TECHNICAL BULLETIN	
	April 2000 TB 1785
Mfg:	FORD
Model:	EXPLORER
Liter:	4.0L
V I N:	E
Year:	97-09

Knocking Noise At Start-Up On
1997-2000 Ford 4.0L VIN E Engines

Bulletin Diagram: FIGURE 1. TIMING CHAIN TENSIONER - ENGINE ASSEMBLY

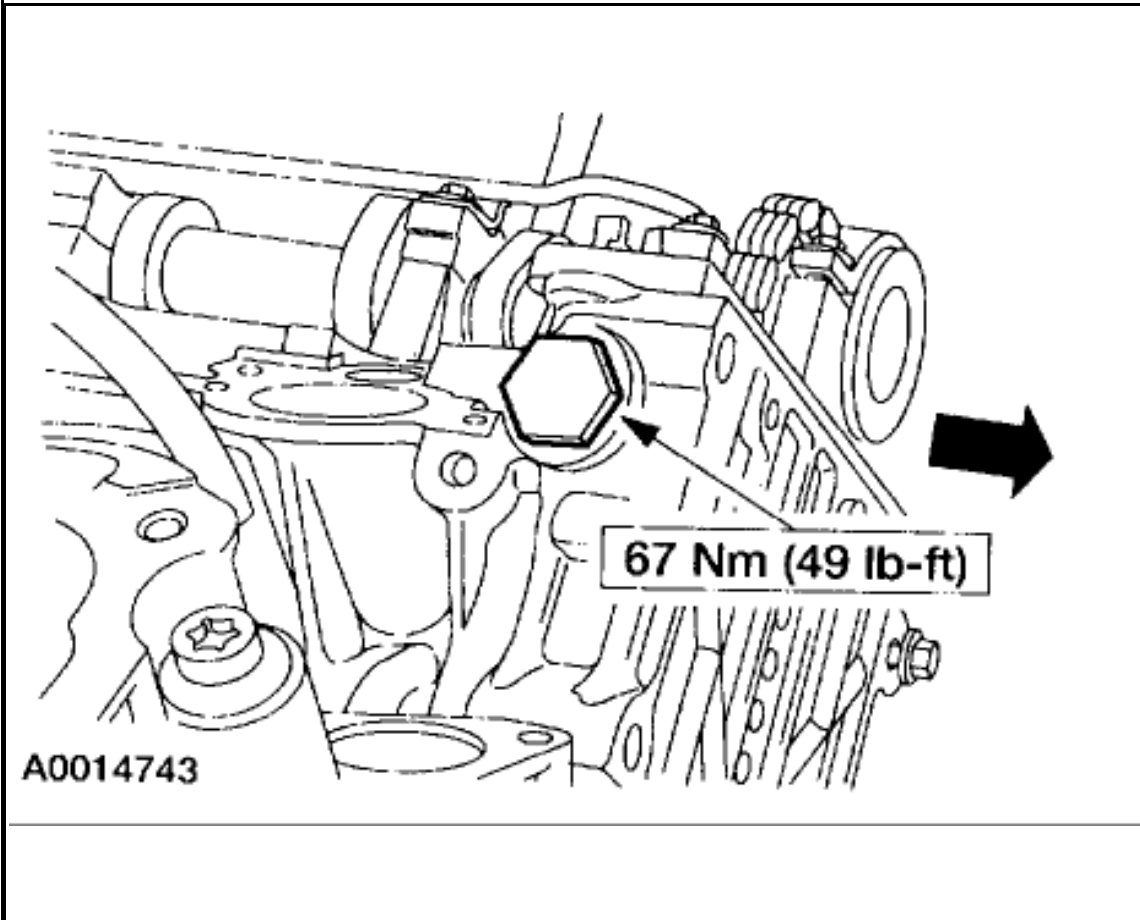
The AERA Technical Committee offers the following information concerning a knocking noise on 1997-2000 Ford 4.0L VIN E engines. A knocking noise at start-up coming from the engine left front has been reported. This noise may last up to two minutes and may or may not be audible on a hot restart after two minutes.

The cause of this noise may be due to air that entered the left-hand chain tensioner when the engine is shutdown. Excessive oil may be emptying from the tensioner when the engine is not running. The time frame to refill the tensioner may vary depending upon various factors (oil used, temperature and RPM).

Ford now offers a revised left side tensioner to help in reducing the likelihood of this condition. A tensioner kit including installation instructions is currently available from Ford with Part #XU2Z-6K254-AA.

Warning! This left-hand tensioner must not be used on the right side of the engine or engine failure will result.
